Chapter 5

5.0 OPERATIONS

FIGURE 5.1-1
OPERATIONS SEQUENCE
(TYPICAL)
Revision 2

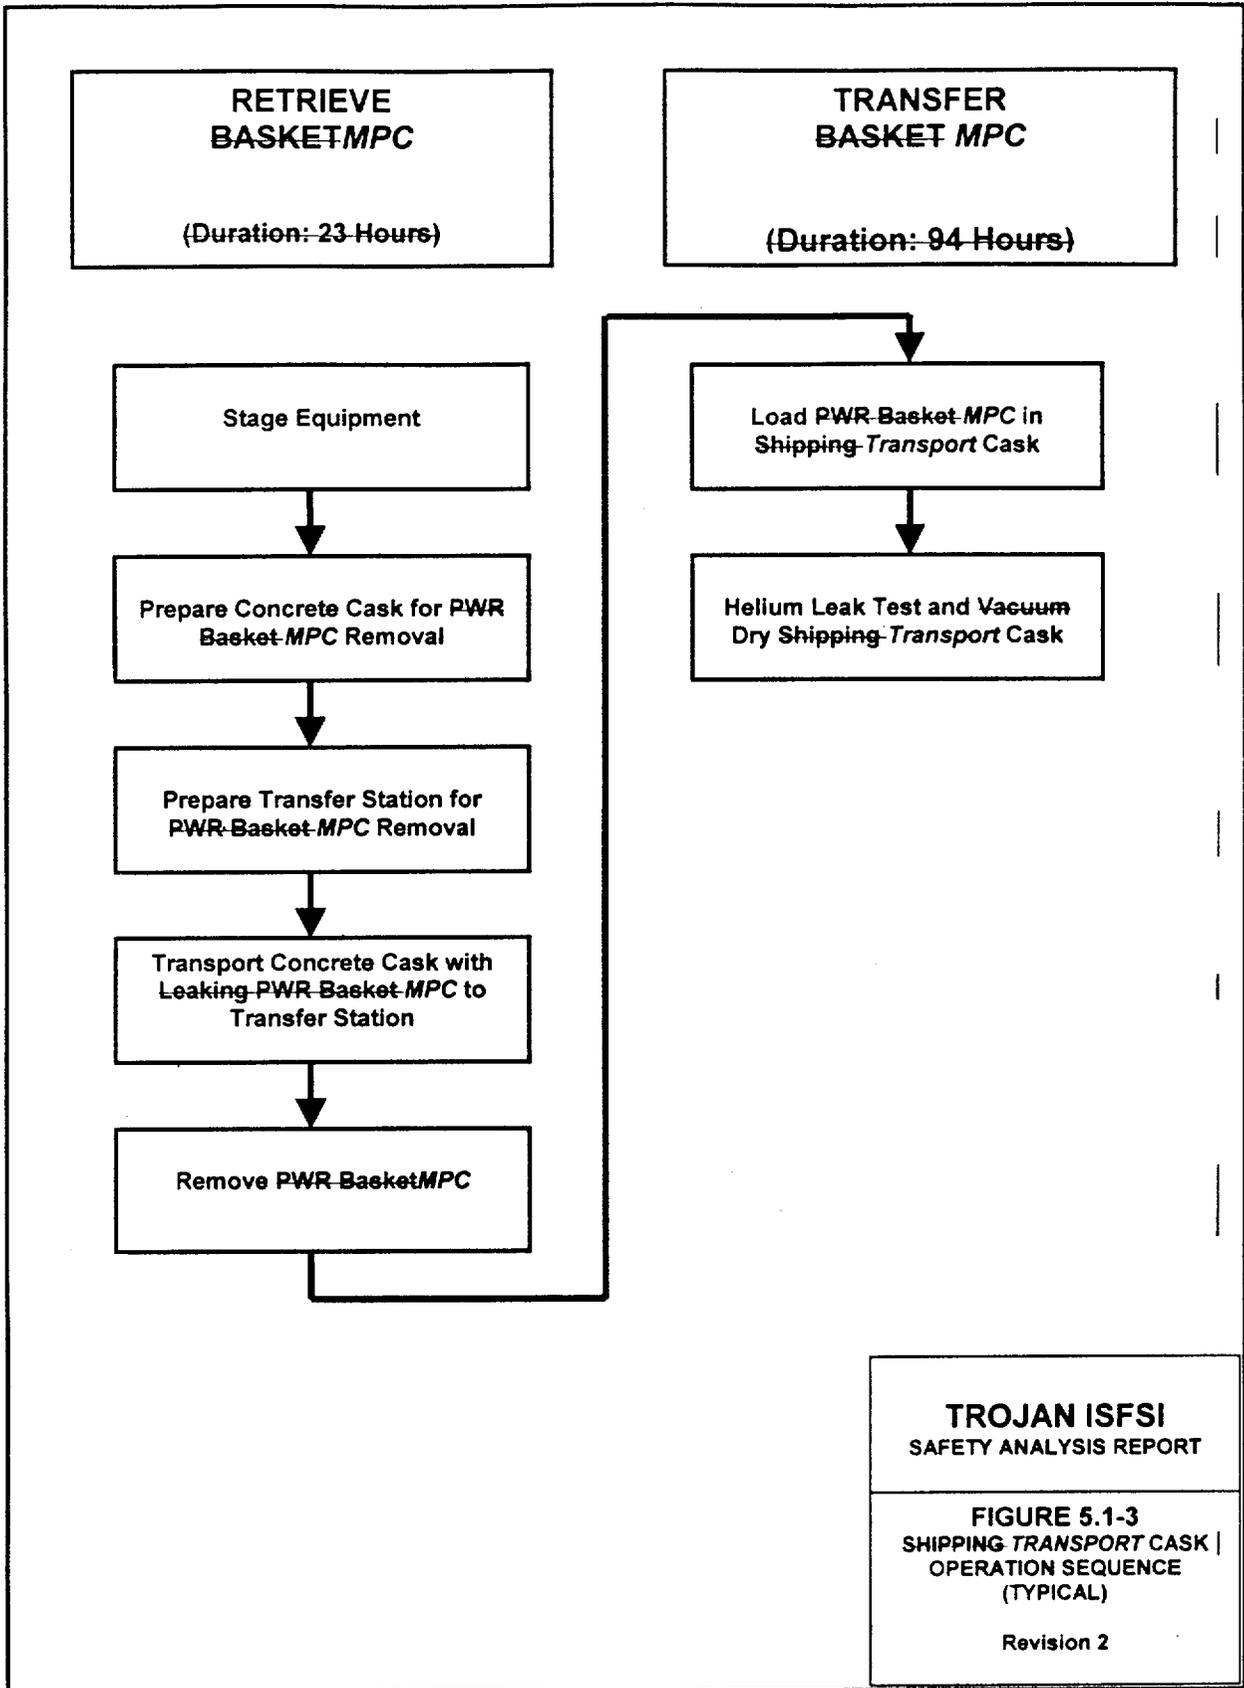
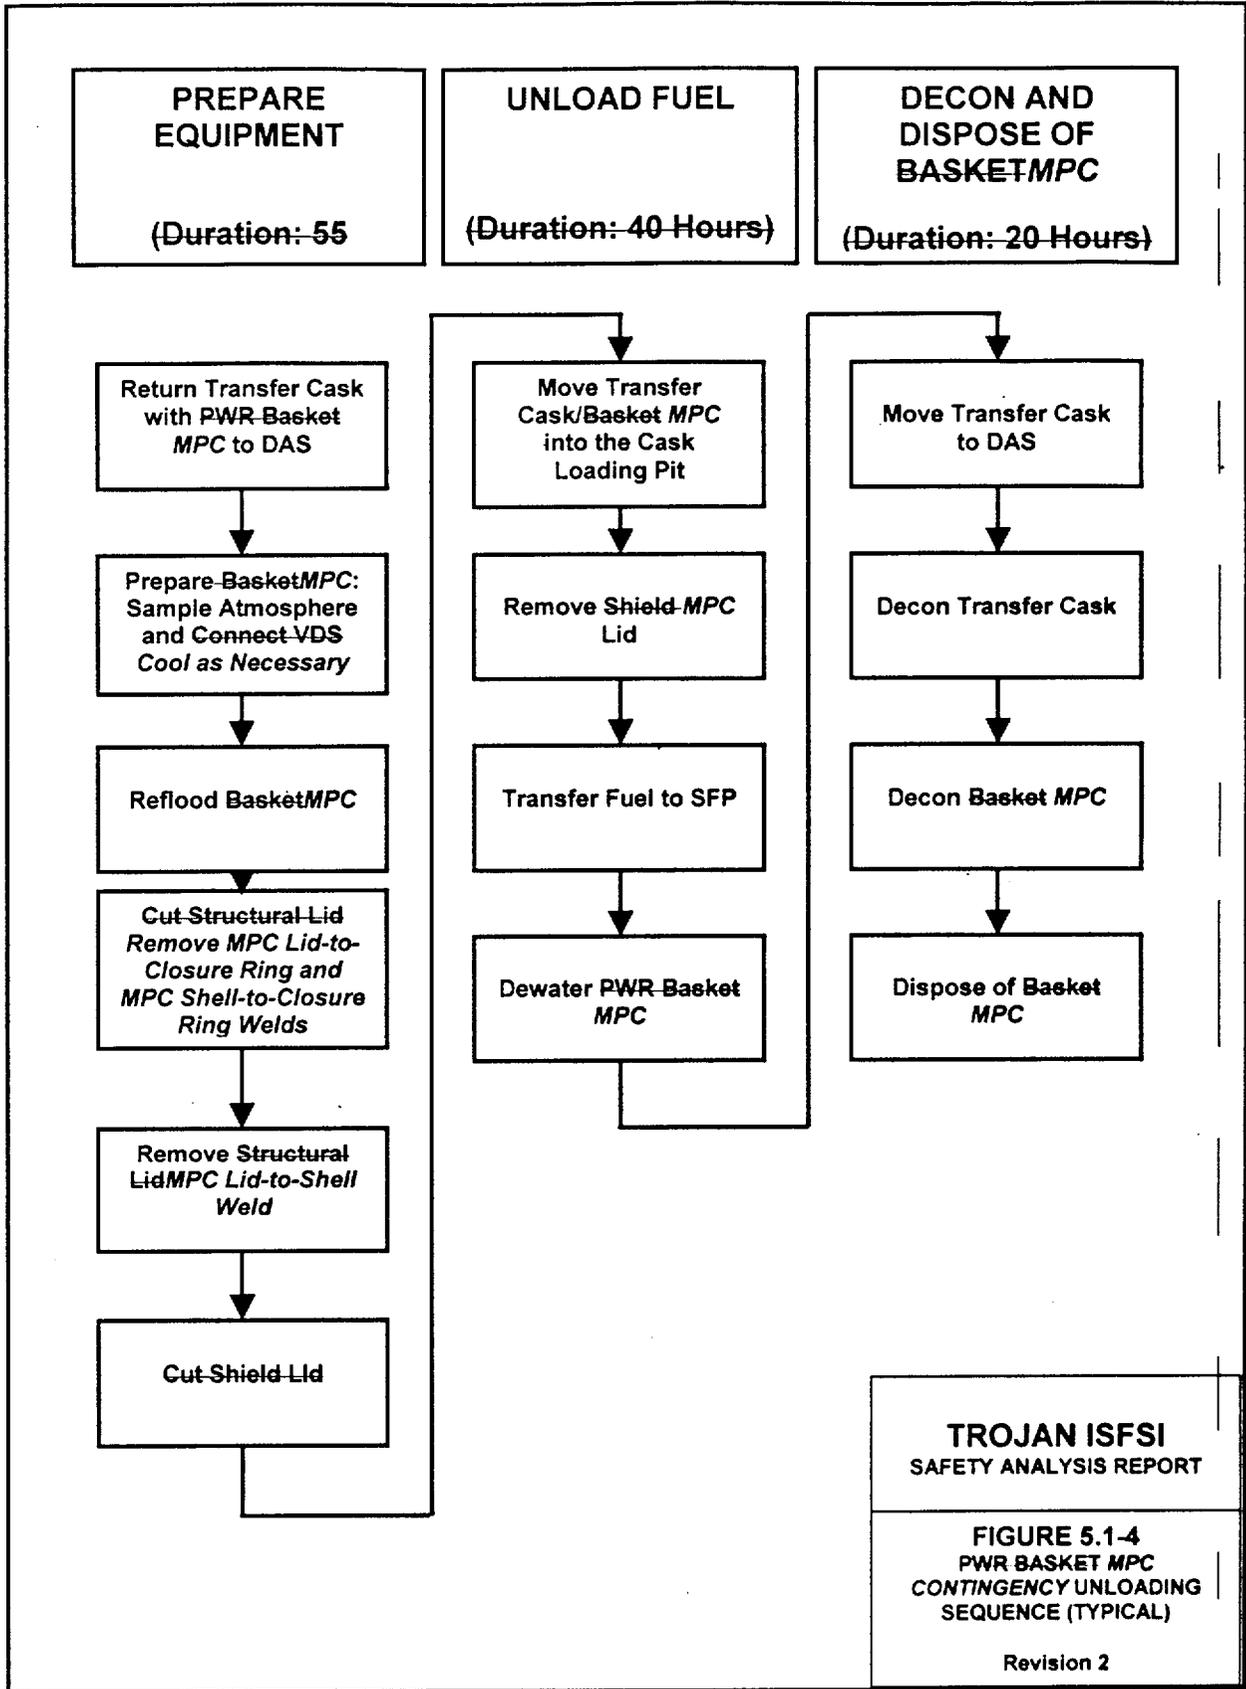
Figure 5.1-1 contains an operation sequence flowchart of ~~PWR Basket MPC~~ loading, sealing, testing, and storage operations ~~including anticipated task completion times.~~

TROJAN ISFSI SAFETY ANALYSIS REPORT
FIGURE 7.3-1 ISFSI PAD CONFIGURATION
REVISION 2

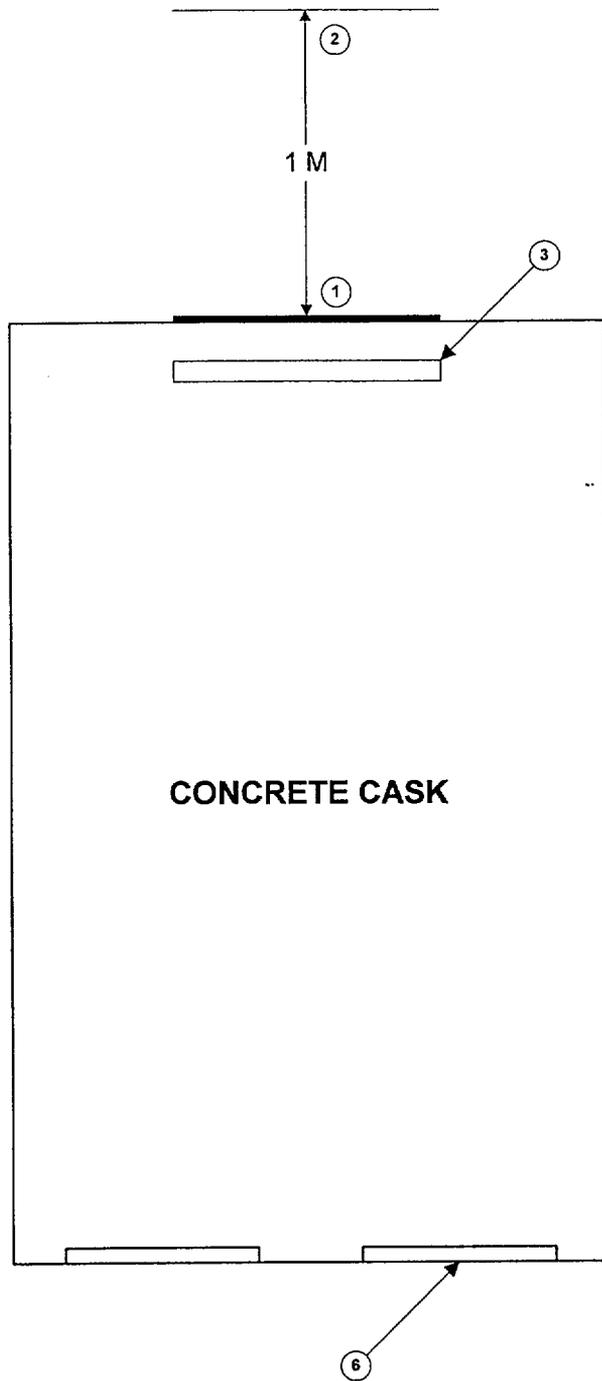
<u>LOCATION</u>	<u>DOSE RATE (mrem/hr)</u>
1	156.5-275.3
2	133.9-111.1
3	6.76-38.7
4	49.4-13.7
5	10.2-6.5
6	18.77-3.9
